Access Compliance Report

Public Rights-of-Way

| Intersection ID: 50335 | Main Street: MILLIE_LN | Cross Street: LEVY_WY | Location: NW |
| ADA ID: 088B859ACDEC | Ramp Type: Perp | Initial Pass/Fail: Fail | Overall Compliance: No |

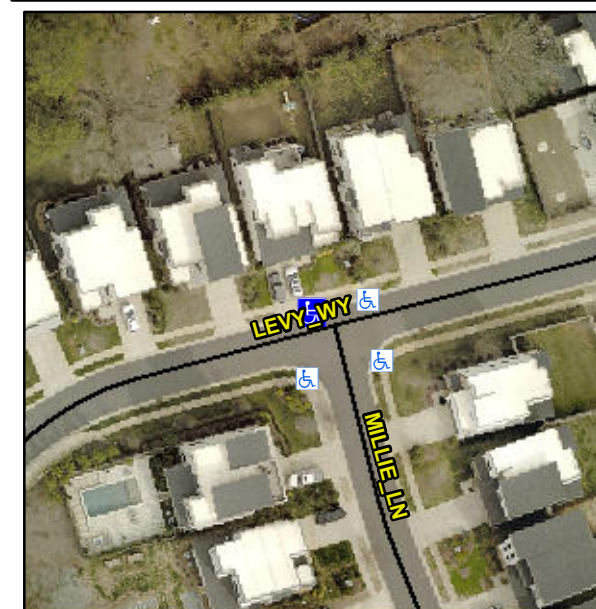
Not Found, R304.5.1, R304.5.3

| Compliance | Description | Data | Compliance | Description | Data |
|------------|-----------------------|------|------------|-----------------------------|------|
| N/A | Ramp Length (in) | 48.0 | Yes | Ramp Slope (%) | 7.7 |
| No | Ramp Width (in) | 47.0 | No | Ramp XSlope (%) | 4.2 |

Remove & Replace Entire Ramp.
